CLASS 1 MODIFICATIONS TO HANFORD FACILITY RCRA PERMIT

CLASS 1 MODIFICATIONS FOR QUARTER ENDING - XQH3□, 201□
Ms. S. L. Dahl-Crumpler, Ecology

Hanford Facility RCRA Permit Modification Notification Form

Unit:	Permit Part
N/A	**Standard and General Conditions**

~~Figure B.1. 200 Area Effluent Treatment Facility Floor Plan~~

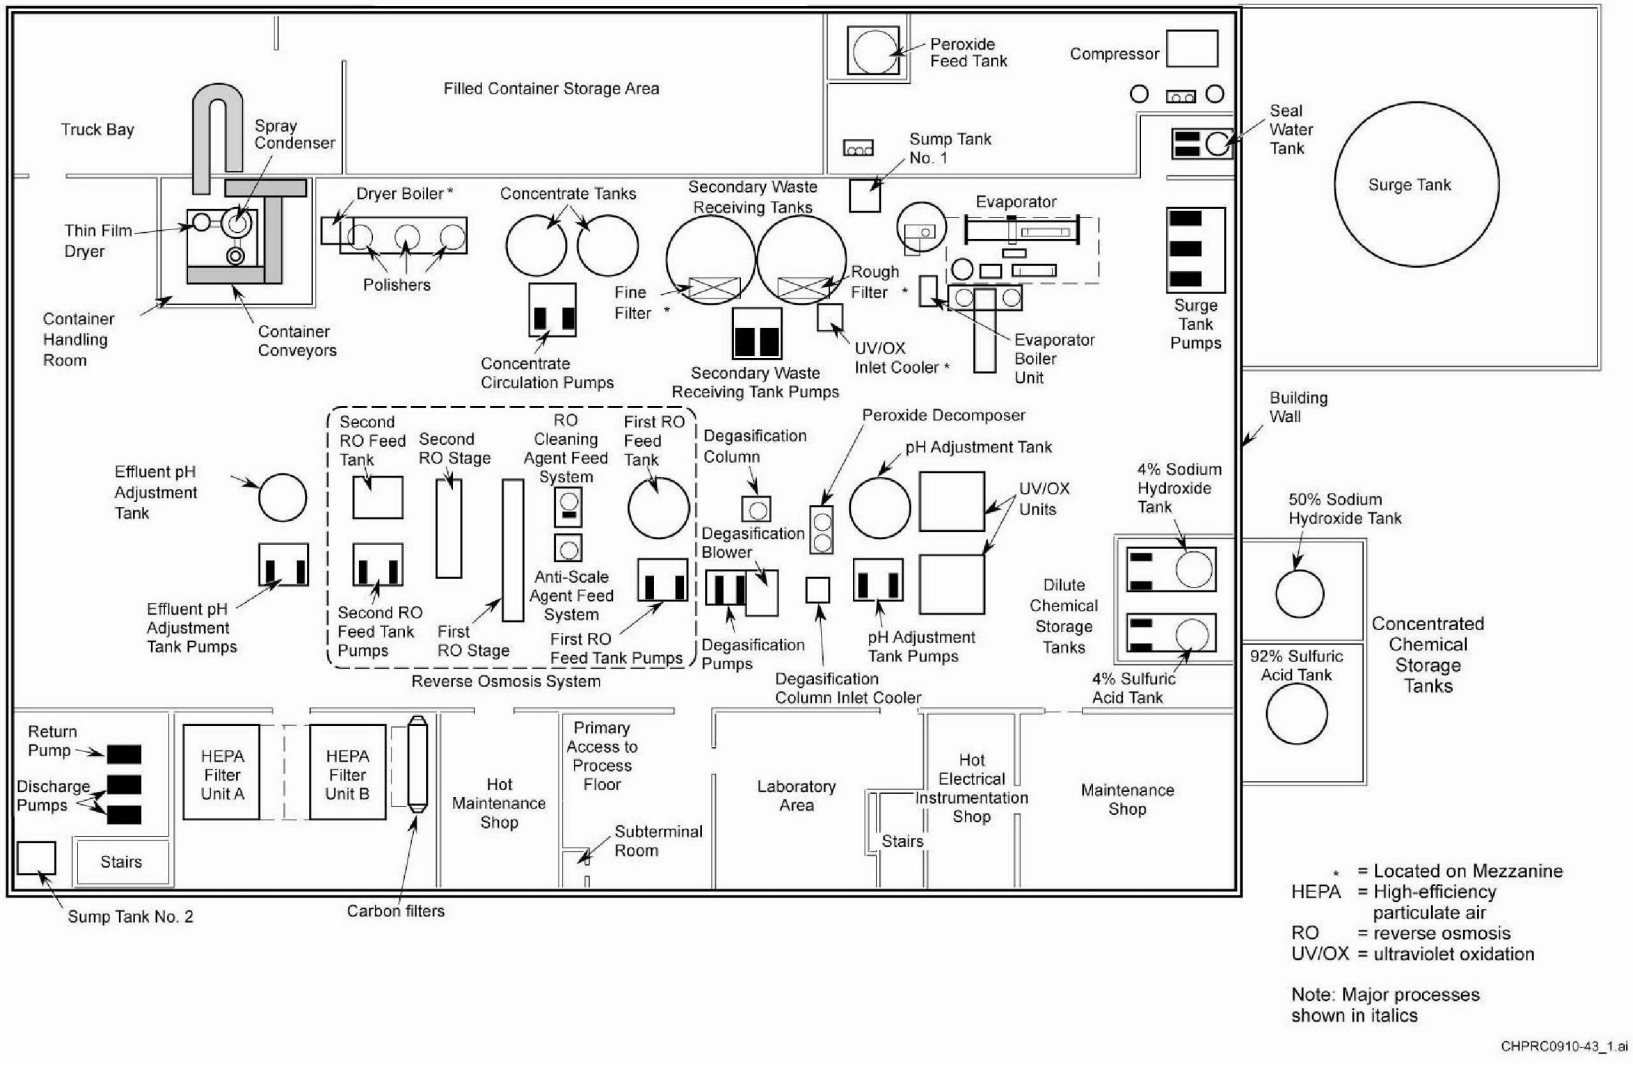
- Table of Contents and Figure B.1: Deleted Figure B.1, and Figures from Table of Contents. Figure B.1 was deleted because the figure is already provided in Addendum C, Figure C.3 where the systems are described.

Figure C.2. Plan View of the 200 Area Effluent Treatment Facility

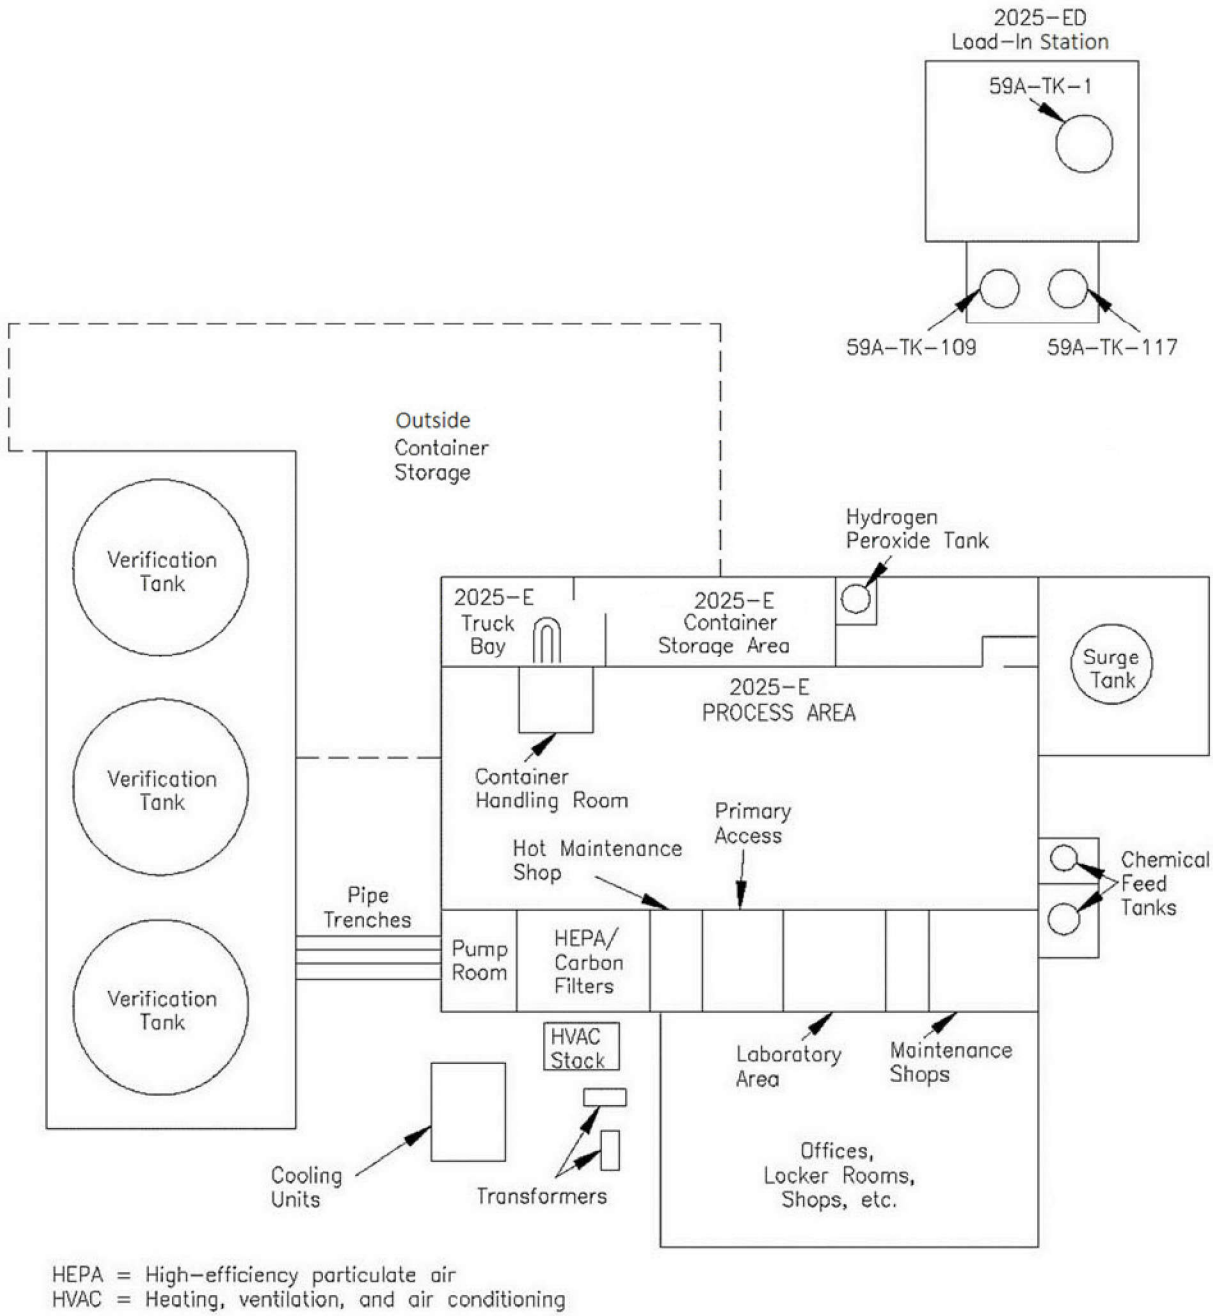
- Figure C.2, Plan View of the 200 Area ETF: Updated figure to include areas referenced in text.
- Figure C.3, 2025-E Building Ground Floor Plan: Updated Figure and title to include area referenced in text.

~~Figure C.4. 200 Area Effluent Treatment Facility~~

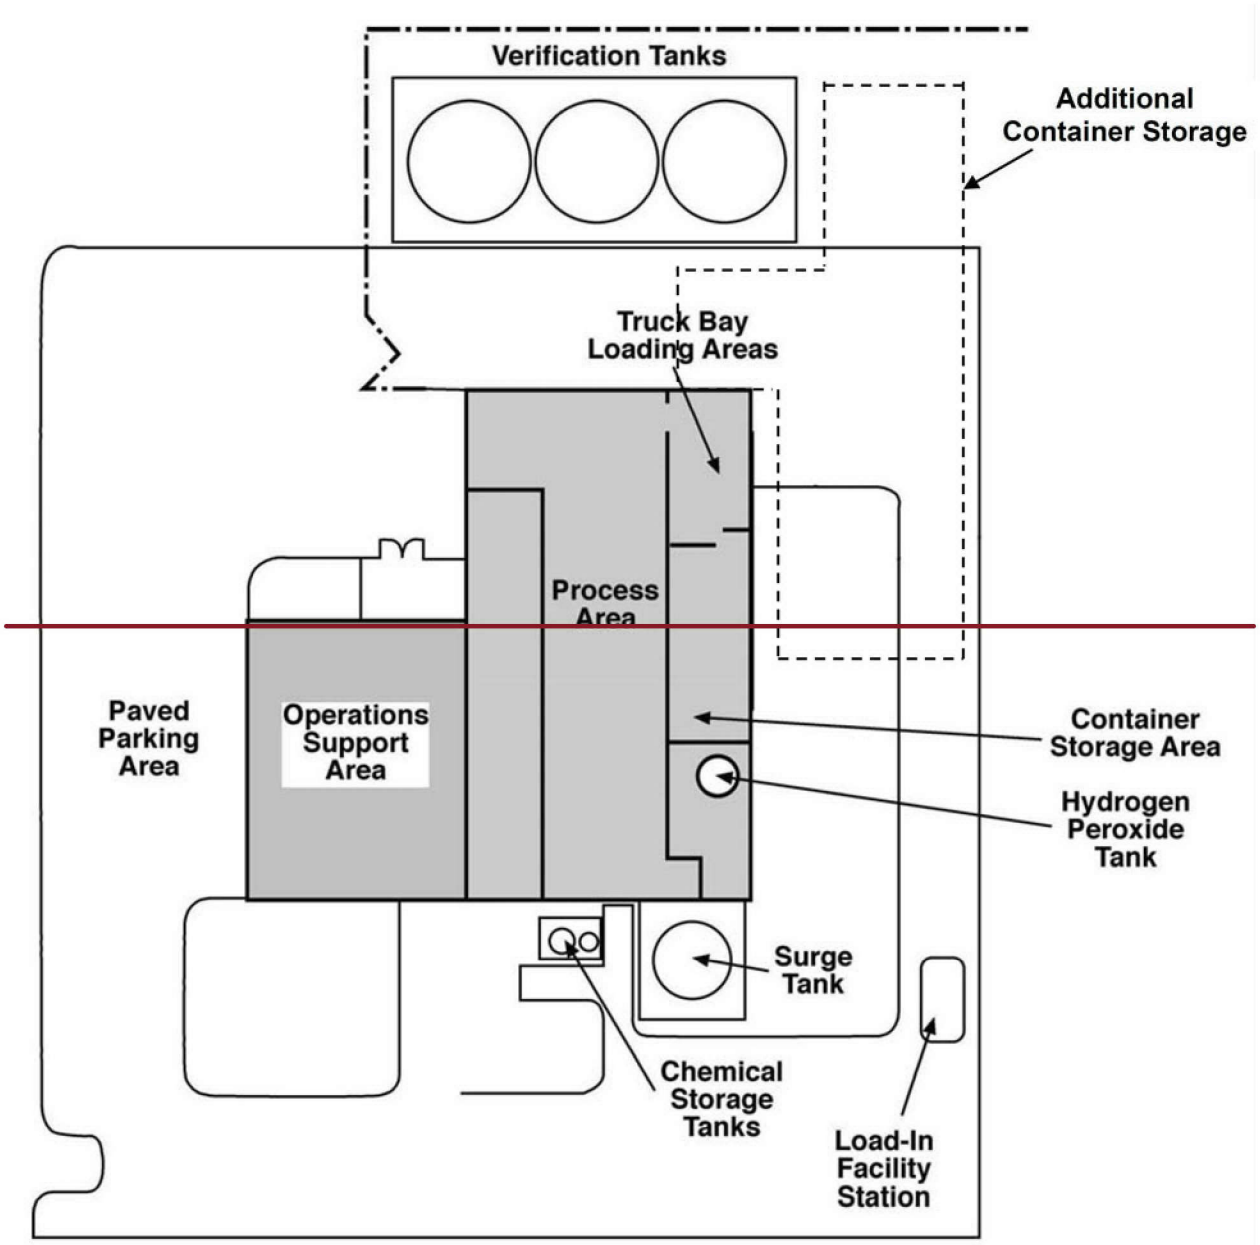
- Figure C.4, 200 Area ETF: Deleted Figure C.4 because the information is provided in Figures C.2 and C.3; as a result Figures C.4 through C.17 were renumbered throughout document.
